TECHNICAL EVALUATION REPORT
SURRY POWER STATION UNITS 1 AND 2
STATION BLACKOUT EVALUATION

TAC Nos. 68611 AND 68612

U.S. Nuclear Regulatory Commission
Washington, D.C. 20555

FIGURE 1

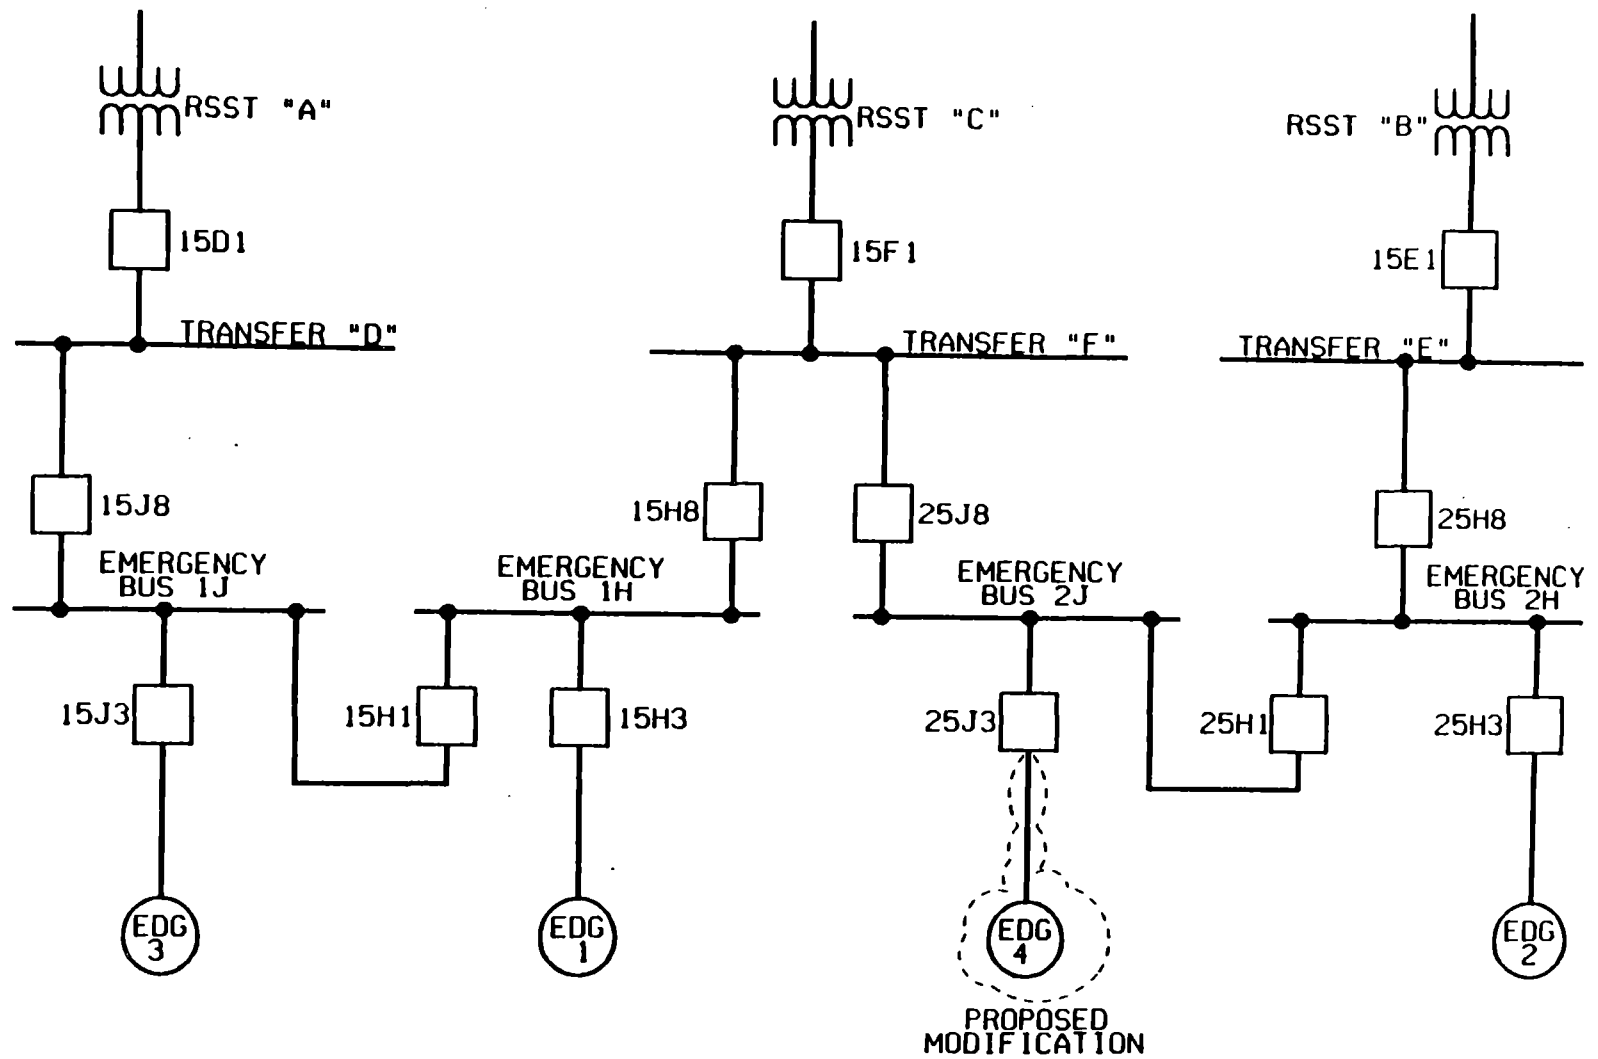
3. At each unit, there two divisions of 4.16 kV emergency buses, each division is normally powered from a separate and independent offsite power source through a reserve station service transformer (RSST), see Figure 1 (21).

4. Upon the loss of RSST "A" or "B," power can be transferred through either transfer bus "D" or "E" using a proposed new manual non-safety grade cross-tie which enables the direct connection of emergency bus 1J to emergency bus 2H.

5. Upon the loss of RSST "C," the connected emergency buses (Bus 1H or 2J) can only be powered by backfeeding through either circuit breaker 15H1 or 25H1 from emergency bus 1J or 2H, respectively. This means of providing power does not conform to the operating guidance regarding the independence of the emergency trains in a unit.

We do not agree with the licensee's statement in the August 1, 1990 submittal (16) that the two switchyards are electrically independent. A review of Figure 8.3-1 of the Surry UFSAR indicates that the emergency busses in both units are normally powered from auto-transformers 1 and 2. These auto transformers connect the two switchyards. Therefore, the switchyards are electrically connected and can not be considered as independent.

Using the guidance provided in Table 5 of RG 1.155 the independence of the offsite power system grouping is "I3." This conclusion is driven by the configuration discussed in item 5 above.

The licensee's proposed AAC power source configuration, see Figure 1, conforms to a variation of an acceptable configuration provided in NUMARC 87-00, and NUMARC 87-00 Supplemental Questions/Answers under Question C.1 (15). The AAC power source, one of the site EDGs, meets all the required criteria in Appendix B of NUMARC 87-00 except for the following cases:

Based on the above, we conclude that the licensee's proposed AAC power source does not conform to the requirements of the SBO rule, and the licensee needs to provide an alternate power source to support the required SBO loads identified in its submittal.

Our review also identifies another potential modification which has a potential impact on minimum coping duration. Cross-ties between

transfer Buses "D" and "F" and Buses "E" and "F," (see Figure 1), would allow the site to be classified as "I2" and "P2*" with a required coping duration of four hours instead of eight hours.
